AIRWORTHINESS DIRECTIVE

TYPE AFFECTED: ASK 13

SUBJECT: Inspection of the root rib dive brake belcrank support brackets and adjustment of the dive brake overcenter.

SHEET: 2 of 2	ASK 13 Technical Note No. 14	Alexander Schleicher GmbH & Co. Segelfluggzeugbau D-6416 Poppenhausen
------------------	------------------------------------	--

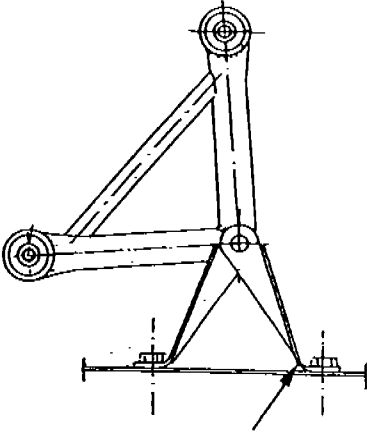
3.4 Take care that the toggle must not go over the dead point which would cause the airbrakes to extend again.

1. Carefully inspect the bearing brackets of the airbrake control circuit at the wing root ribs as well as the root ribs themselves for damage, cracks etc. In case of doubt the paint must be removed off the bracket. In most cases the breaks were found at the bottom of the front bearing bracket; refer to the drawing on Sheet 2 of this TN !
Where damages at one bearing bracket are found, this part must be exchanged; where a root rib is damaged, it requires repair.
